**The Hall School**  
**23 Crossfield Street, London NW3**  
**Basement Impact Assessment**  
**Audit**

For  
London Borough of Camden

Project Number: 12466-38

Revision: F3

Horizontal Displacement Contours: Grid 1 (level 0.000m) Interval 1mm

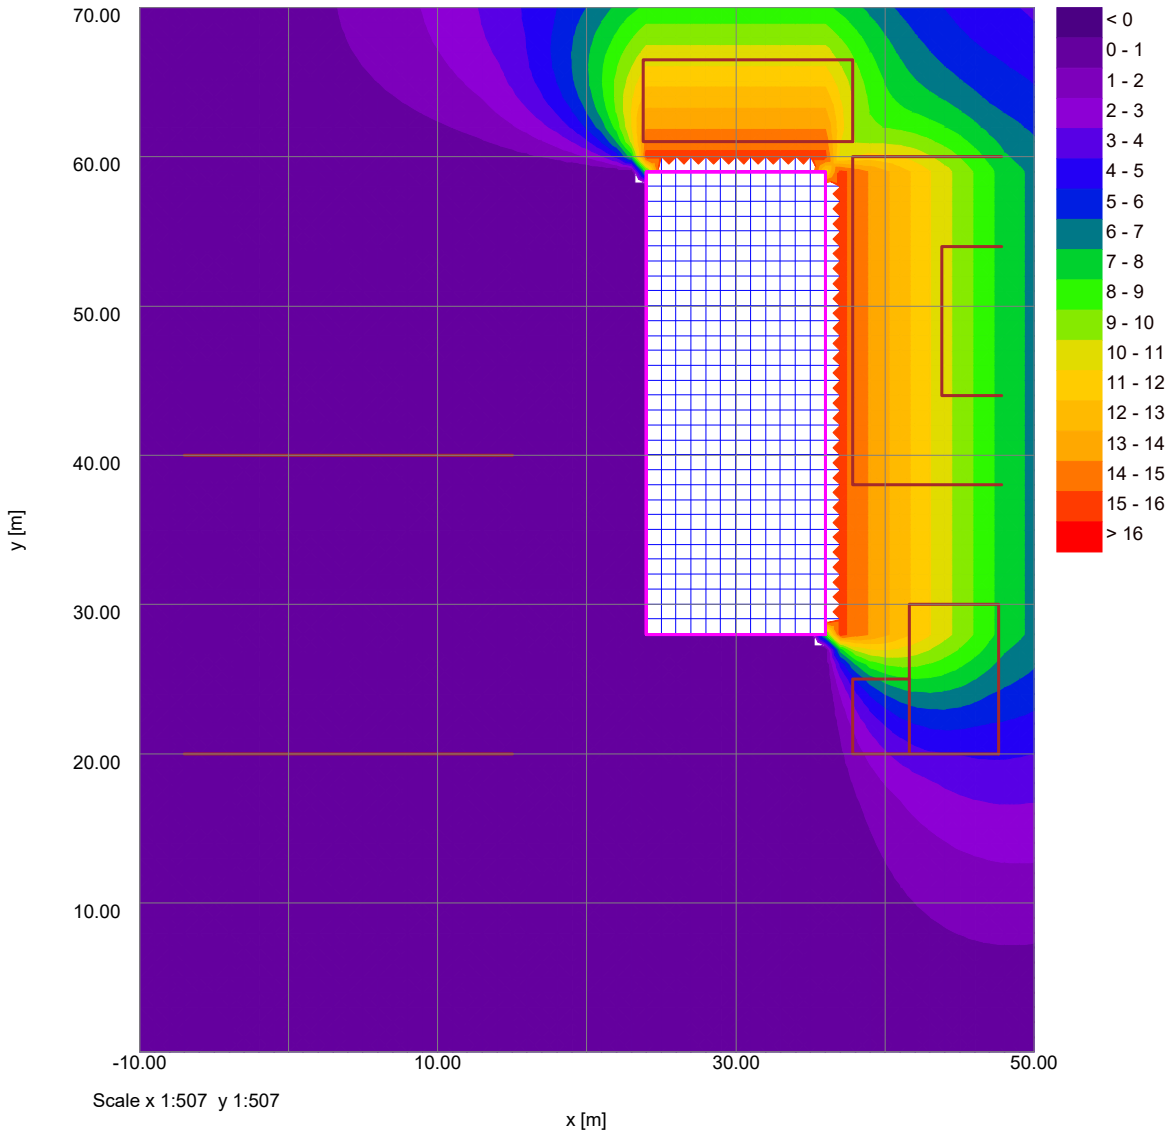
1. **Transferral of the Wallap movements into X-Disp.** The ground movements associated with the piled wall are based on the specific Wallap analysis undertaken whereby the peak horizontal deflection of 13 mm has been factored by 2/3 to produce an equivalent uniform deflection of 8.7 mm which when normalised by the excavation depth of 8.2 m gives a relationship of 0.106 % excavation depth. This has been used to produce a new X-Disp movement curve for the excavation phase. Page 310 of the BIA shows where this has been applied together with the pile installation movements to produce a damage assessment.
